TECHNICAL BULLETIN

[Issue No.] T03-0009

[Title] Notification of Error Correction on Description
of A Programming Manual (Dedicated Instruction Version)

[Relevant Models] A1SJHCPU, A1SHCPU, A2SHCPU, A2SHCPU-S1

<Example of System Configuration for Explanatory Purpose>

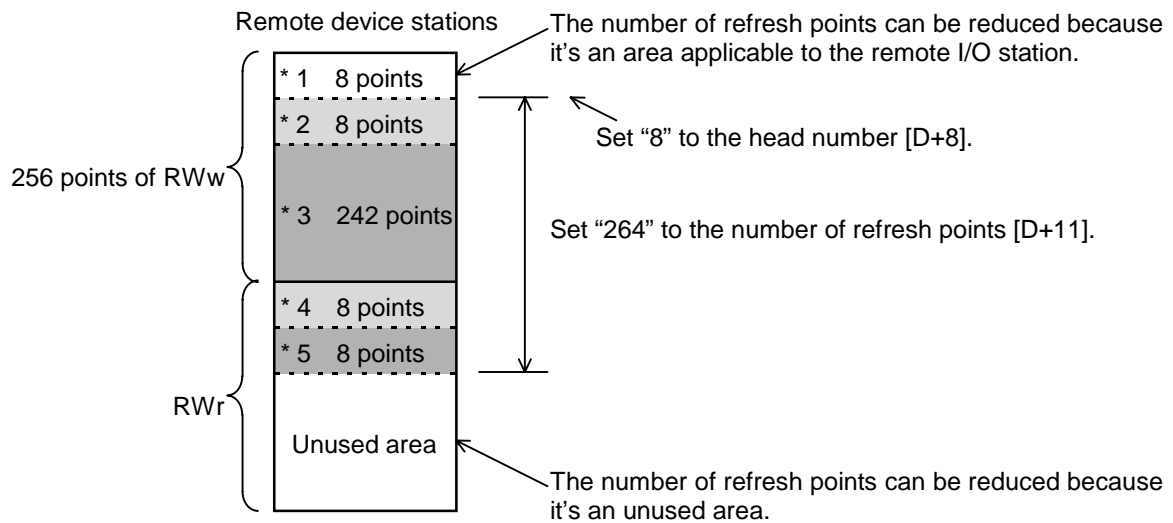
Follow the instruction given below, for saving the device on CPU (the number of refresh points) during refreshing.

(a) 64 stations (256 points) of RWw are assigned in the RW areas even if the total number of stations is less than 64, and therefore the head of RWr comes after those 64 stations of RWw (256 points.)

- *1 : RWw area (for 8 points) applicable to Station No. 1 and 2 (Remote I/O stations)
- *2 : RWw area (for 8 points) applicable to Station No. 3 (Remote device station)
- *3 : RWw area (for 242 points) occupied automatically in the system
- *4 : RWr area (for 8 points) applicable to Station No. 1 and 2 (Remote I/O stations)
- *5 : RWr area (for 8 points) applicable to Station No.3 (Remote device station)
